Contract #: 04-0120F4Cty: SF/ALA Rte: 80 PM: 13.2/13.9File #: 69.25B**QUALITY ASSURANCE -- NON-CONFORMANCE REPORT****Location:** Changxing Island, Shanghai, China**Report No:** NCR-000785**Prime Contractor:** American Bridge/Fluor Enterprises, a JV**Date:** 03-Jul-2010**Submitting Contractor:** Zhenhua Port Machinery Company, Ltd (ZPMC), Changxing Island**NCR #:** ZPMC-0747**Type of problem:****Welding****Concrete****Other****Welding****Curing****Procedural****Bridge No:** 34-0006**Joint fit-up****Coating****Other****Component:** Traveler Rail Welds 20TR2-004-011, -016-004**Procedural****Procedural****Description:****Reference Description:** Missed MT Indications by QC**Description of Non-Conformance:**

| Subject: | NCR No. ZPMC-0747 | Document No: | 05.03.06-000742 |

NCR PROPOSED RESOLUTION

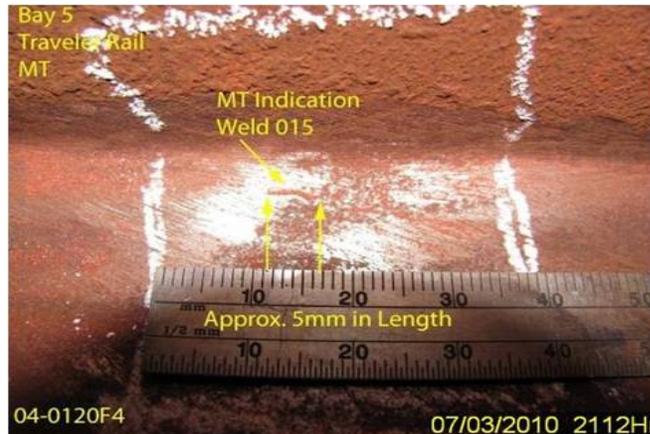
-During Quality Assurance Magnetic Particle Testing (MT) review of welds located on Orthotropic Box Girder(OBG) Traveler Rails, QA discovered the following issues:

- Weld identified as: 20TR2-004-011.
- One Longitudinal Linear crack indication was missed by ZPMC measuring approximately 5mm.
- The "Y" location is approximately 220mm directly across from the end of weld 015.
- Weld identified as: 20TR2-016-004.
- One Linear crack indication was missed by ZPMC measuring approximately 20mm.
- The "Y" location is approximately 520mm from the end of weld 015.
- The welds are fillet welds joining flange to web.
- The fillet weld size measured to be 6 mm.
- Traveler Rails are located in the OBG Sub assembly Bay#5.

AWS D1.5 2002 Section 6 figure 6.8 – specifies for fillet weld sizes up to 6mm the maximum discontinuity length is approximately 1.6mm.

AWS D1.5 2002 section 6.26.2 – “Welds that are subject to RT or Magnetic particle Testing (MT) in addition to visual inspection shall have no cracks...”

Reference Resolution: ZPMC has issued an internal NCR and has discussed preventative measures with the ABF QCM. ZPMC has attached the acceptable MT report after repair. ZPMC requests closure of this NCR.

The proposed resolution is acceptable with action pending. Please provide MT record for weld joint 20TR2-004-015.

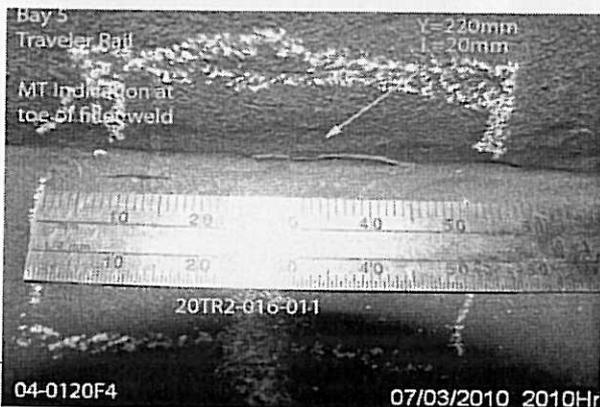
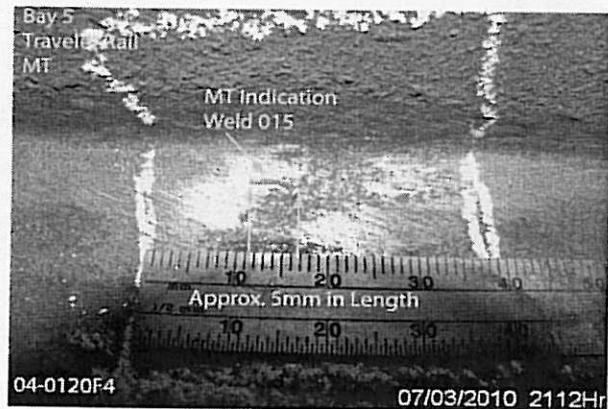
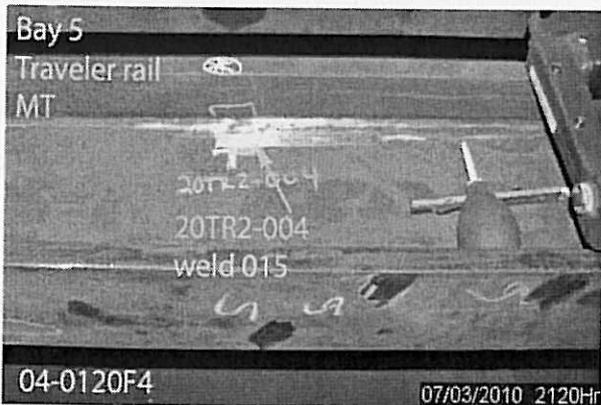
-During Quality Assurance Magnetic Particle Testing (MT) review of welds located on Orthotropic Box Girder(OBG) Traveler Rails, QA discovered the following issues:

- Weld identified as: 20TR2-004-011.
- One Longitudinal Linear crack indication was missed by ZPMC measuring approximately 5mm.
- The "Y" location is approximately 220mm directly across from the end of weld 015.
- Weld identified as: 20TR2-016-004.
- One Linear crack indication was missed by ZPMC measuring approximately 20mm.
- The "Y" location is approximately 520mm from the end of weld 015.
- The welds are fillet welds joining flange to web.
- The fillet weld size measured to be 6 mm.
- Traveler Rails are located in the OBG Sub assembly Bay#5.

AWS D1.5 2002 Section 6 figure 6.8 – specifies for fillet weld sizes up to 6mm the maximum discontinuity length is approximately 1.6mm.

AWS D1.5 2002 section 6.26.2 – “Welds that are subject to RT or Magnetic particle Testing (MT) in addition to visual inspection shall have no cracks...”

Reference Resolution: ZPMC submitted NDT records after repair to show that the welds with the indications have been successfully repaired.

Weld ID 20TR2-004-015 did not have any indications it was being used by the inspector to reference the location of the indications found in 20TR2-004-013 and 20TR2-016-011. ZPMC submitted NDT records after repair to show that the welds with the indications have been successfully repaired. The weld IDs referenced in the NCR have been corrected to reflect the actual weld ID. Based on this ZPMC requests closure of this NCR.

The submitted documentation is sufficient to close the NCR.

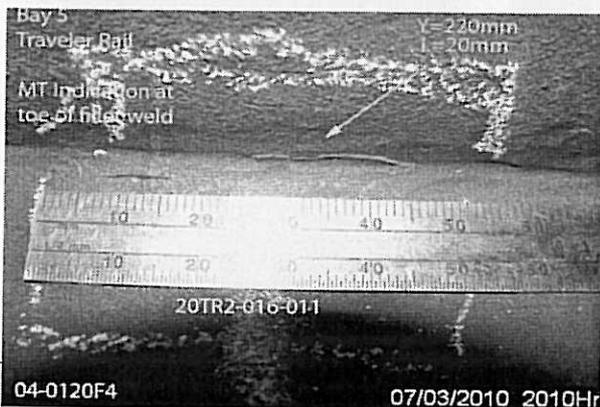
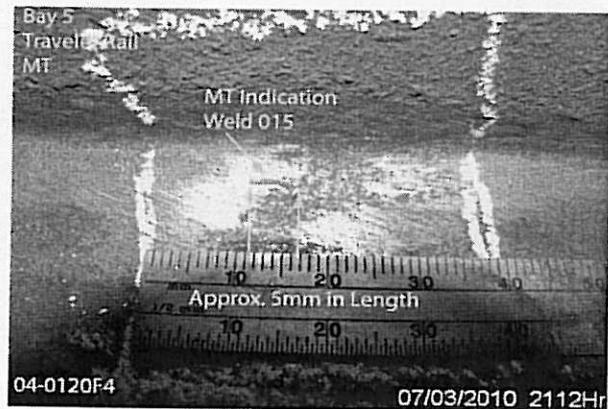
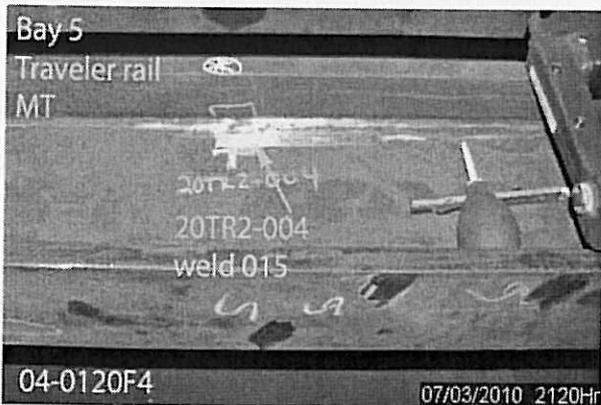
-During Quality Assurance Magnetic Particle Testing (MT) review of welds located on Orthotropic Box Girder(OBG) Traveler Rails, QA discovered the following issues:

- Weld identified as: 20TR2-004-011.
- One Longitudinal Linear crack indication was missed by ZPMC measuring approximately 5mm.
- The "Y" location is approximately 220mm directly across from the end of weld 015.

- Weld identified as: 20TR2-016-004.
- One Linear crack indication was missed by ZPMC measuring approximately 20mm.
- The "Y" location is approximately 520mm from the end of weld 015.
- The welds are fillet welds joining flange to web.
- The fillet weld size measured to be 6 mm.
- Traveler Rails are located in the OBG Sub assembly Bay#5.

AWS D1.5 2002 Section 6 figure 6.8 – specifies for fillet weld sizes up to 6mm the maximum discontinuity length is approximately 1.6mm.

AWS D1.5 2002 section 6.26.2 – “Welds that are subject to RT or Magnetic particle Testing (MT) in addition to visual inspection shall have no cracks...”

Repair said indication and perform NDT required to verify weld quality.

Contractor supplied post repair NDT documentation verifying weld is in conformance with Contract weld quality requirements. Contractor has also issued an internal NCR in regards to this issues in order to avoid similar issues in the future.
